Determination 2007/67

Retaining wall at 71 Beach Road, Waihi Beach, Western Bay of Plenty

Figure 1: Site plan showing the position of the retaining wall along the north

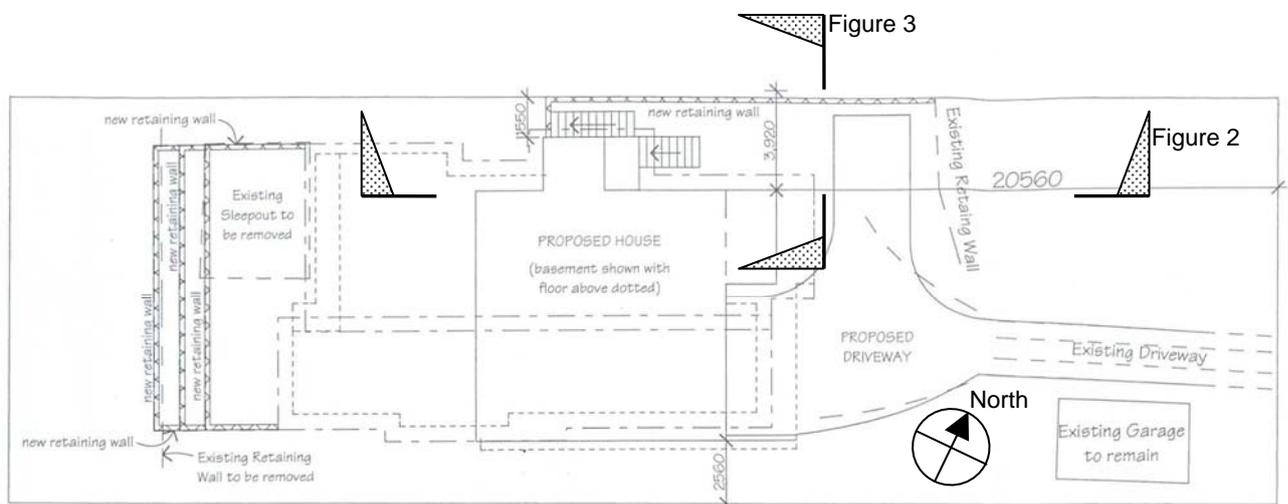
- 2.2.1 In June 2005 the owner applied for and obtained a building consent for the removal of an existing house and the erection of a new one. As shown on Figure 1, the plans and specifications supporting that application showed the retaining wall (and other retaining walls which I have not been asked to consider) on the site plan. However, the plans and specifications contained no other information about the retaining wall, although they did include full details of the house itself.

Figure 2: Ground profile along the north boundary showing height of soil retained (from the application for building consent with heights added)

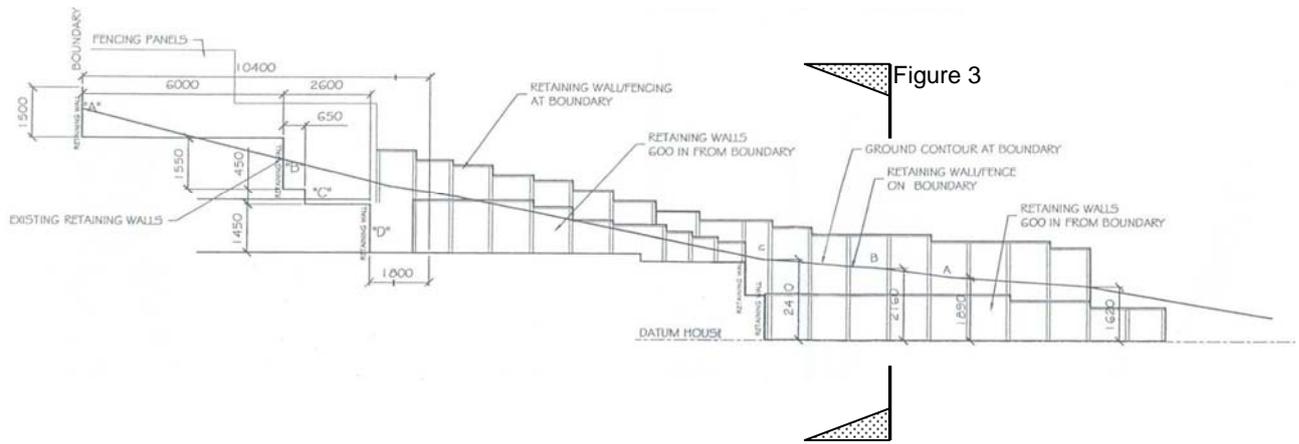
- 2.2.3 The retaining wall as a whole is of varying height and retains a depth of between about 1.1 m and about 2.4 m as shown in Figure 2. It was constructed in two stages, the lower part first by one contractor and the upper part later by another contractor. As shown in Figure 3, both the lower and the upper parts consist of 125 mm x 125 mm posts (which the expert refers to as "poles" and which could also be referred to as "poles") at 1.1 m centres cast into concrete posthole footings, with 150 mm x 50 mm rails spanning horizontally between posts. The posts of the lower part are inclined at 5° off vertical towards the boundary, the posts of the upper part are vertical. The upper part is immediately behind the top of the lower part. The posts of the upper part extend above the retained soil.

- 4.4.11 The plans and specifications for the house do not include specific levels but do indicate that significant excavation would be undertaken, see Figure 2. I note that the plans and specifications do not include any detailed provisions to protect the house and other property from ground instability. I also note that the territorial authority does not appear to have raised the matter when considering the application for building consent.

Figure 3: The retaining wall (taken from the expert's report).

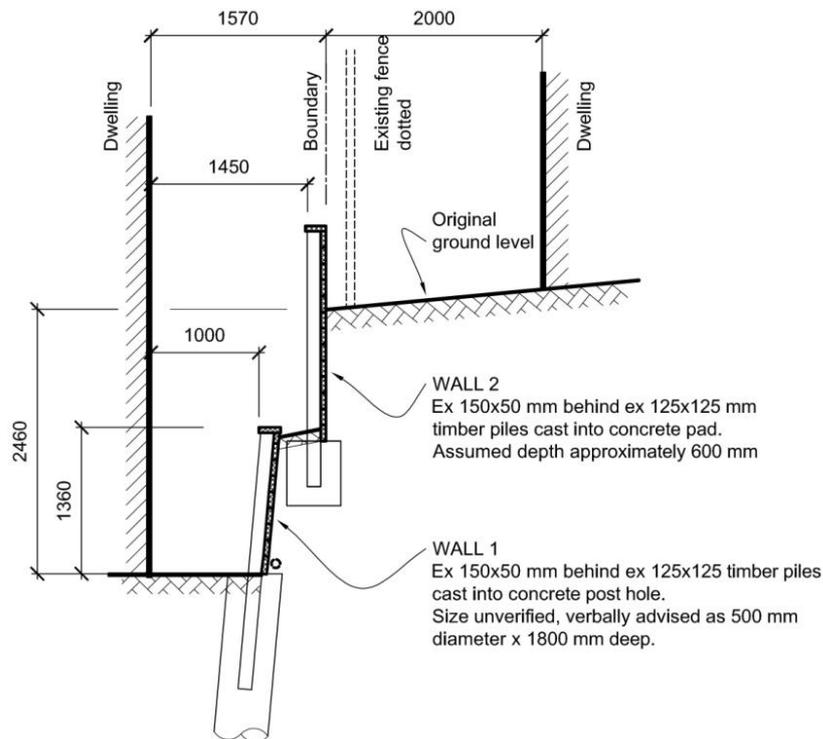
6.2.1 Schedule 1(c) provides that a building consent is not required for a retaining wall that retains not more than 1.5 m depth of ground and that does not support any surcharge. A surcharge is any feature such as sloping ground, or a road, or another building which adds to the load on the wall over and above the load imposed by the depth of soil retained. Accordingly, it is acceptable for a cut to be retained by a series of 1.5 m retaining walls above each other provided that no higher wall imposes a surcharge on a lower wall. That means that there must be a certain horizontal distance between the walls, depending on the particular soil properties of the site. In this case, the distance is insignificant, see Figure 3, and the upper part imposes a load (“surcharge”) on the lower part.

6.2.2 Accordingly, I regard the retaining wall as a single structure in which the lower and upper parts act together to retain the full height of the cut. The lower and upper parts cannot be regarded as separate and independent structures because the upper part depends on the lower part for support and stability.

6.2.3 Even if the lower part were considered on its own, although it is less than 1.5 m high it supports not only the soil immediately behind it but also a surcharge in the form of the loads imposed on it by the structural actions of the upper part and by the soil behind the upper part. Accordingly the construction of the lower part is not exempted from the need for a building consent under clause (c) of Schedule 1.
